Technical Service Bulletin

NUMBER
19-01-028HG

**G80 / G90 TURBO OIL FEED PIPE REPLACEMENT
(RECALL CAMPAIGN 003G)**

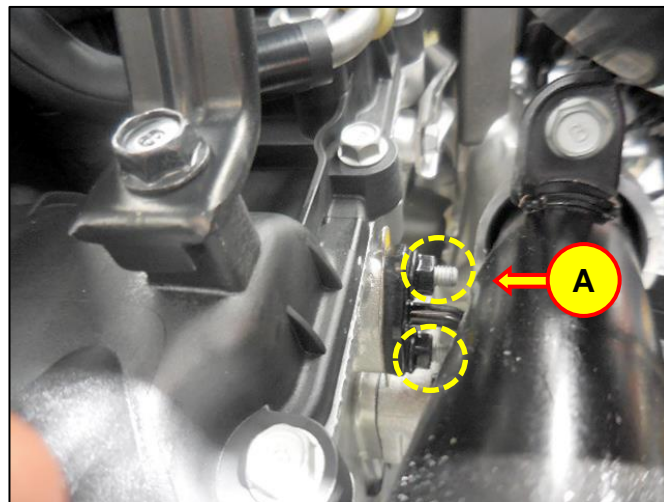
Description: The Left Hand (LH) turbocharger oil feed pipe may have a loose seal causing oil to leak onto the exhaust manifold. Oil leaking onto the exhaust manifold could increase the risk of a fire. This bulletin describes the procedure to replace the LH turbocharger oil feed pipe.

Parts Name	Part Number	Qty	Note
TURBO CHARGER OIL FEED PIPE SERVICE KIT	 28240-3L999QQH	1	SERVICE KIT CONTENTS: (1) OIL FEED PIPE (28240-3L100) QTY 1 (2) GASKET (17512-10000) QTY 2 (3) GASKET (17512-12000) QTY 4 (4) GASKET-T/C OIL FEED (28241-3L100) QTY 1 (5) O-RING (25462-21010) QTY 1

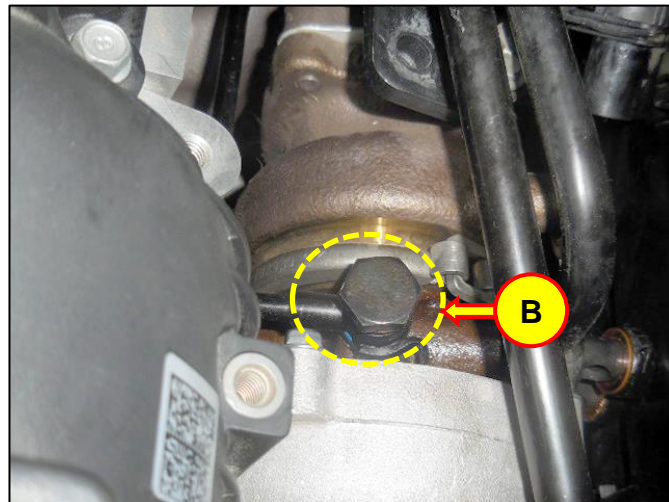
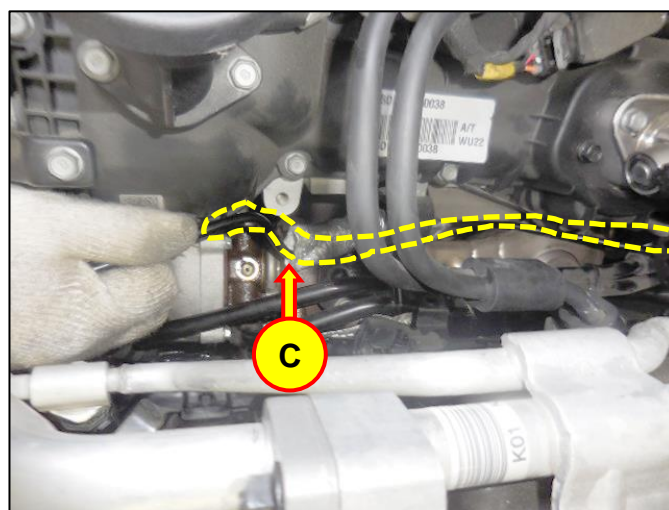
2. Remove the nuts(A) from the LH turbocharger oil feed pipe.

3. Remove bolt (B) from the LH turbocharger oil feed pipe.
- Use new washers from the service kit during reassembly.

Tightening Torque:
9.8. ~ 11.7 Nm (1.0. ~ 1.2 kgf.m,
7.2 ~ 8.6 lb-ft)

Tightening Torque:
11.7. ~ 17.6 Nm (1.2. ~ 1.8 kgf.m,
8.6 ~ 13.0 lb-ft)

4. Remove the LH turbocharger oil feed pipe (C).

5. Install the new LH turbocharger oil feed pipe service kit.
- (1) Oil feed pipe
 - (2) Oil feed pipe gaskets
 - (3) Turbo water pipe gaskets
 - (4) Oil drain pipe gasket
 - (5) Coolant pipe O-ring
6. Reinstall all removed parts in the reverse order of removal. Refill and bleed the cooling system with new coolant.
